U.S. Department
of Transportation
**Federal Highway
Administration**

Maintenance of Pavement Underdrain System

MAINTENANCE OF PAVEMENT UNDERDRAIN SYSTEM

WATER PAVEMENT DAMAGE

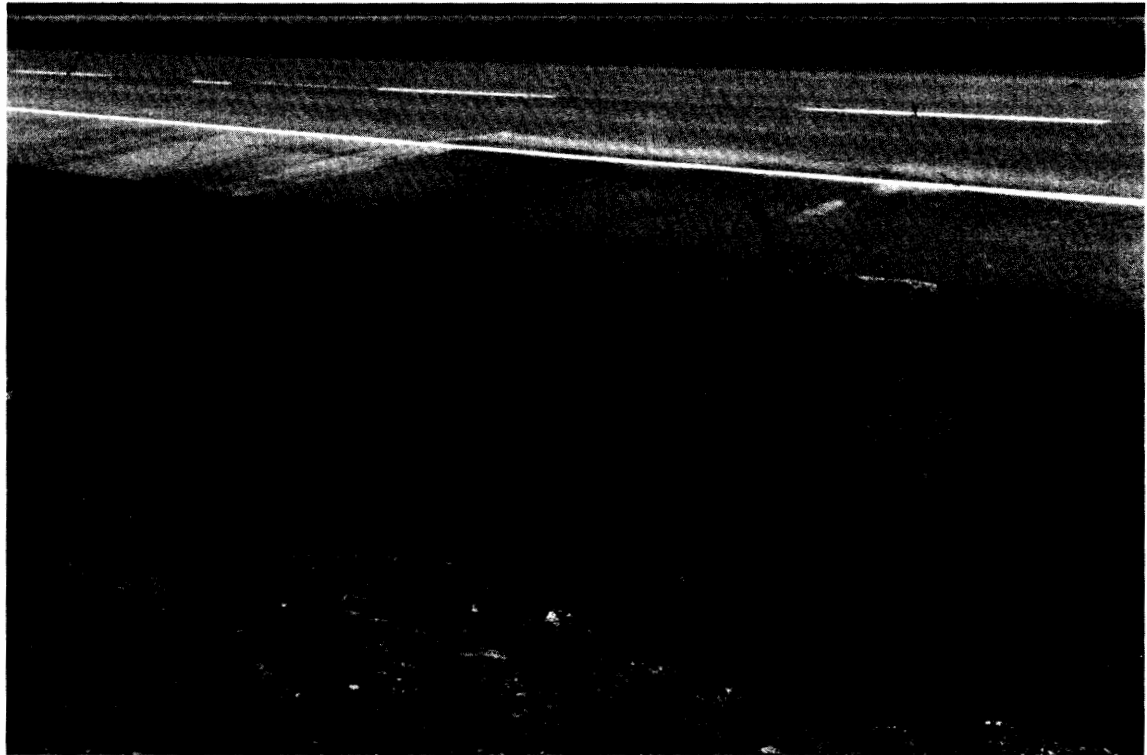
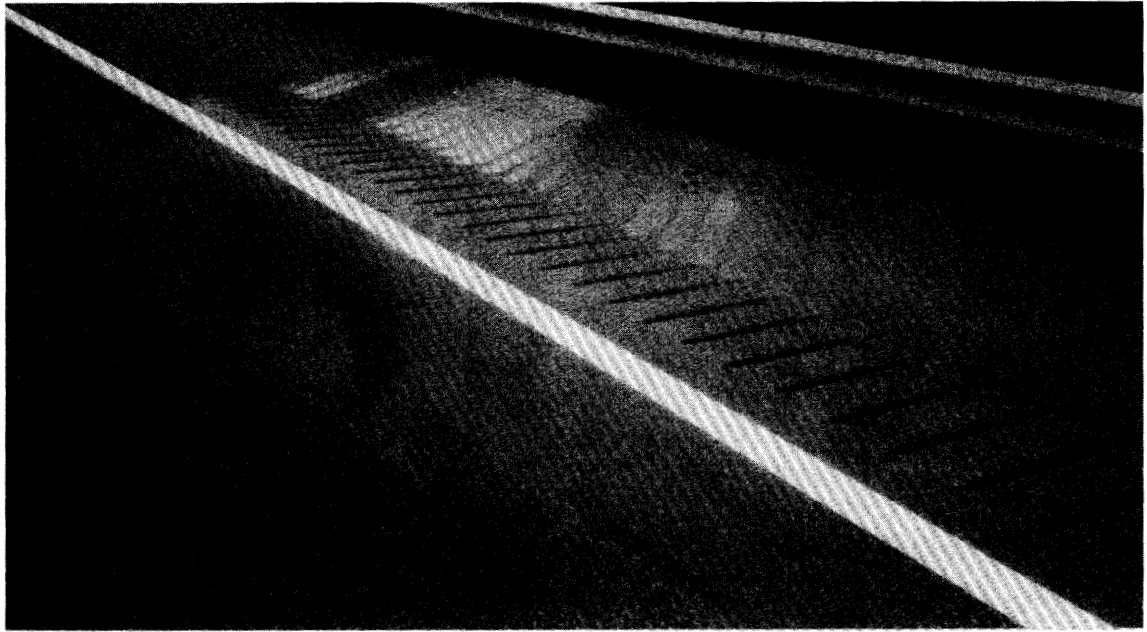
The last page of photographs is of typical pavement damage that results from water in the pavement. (Attachment F)
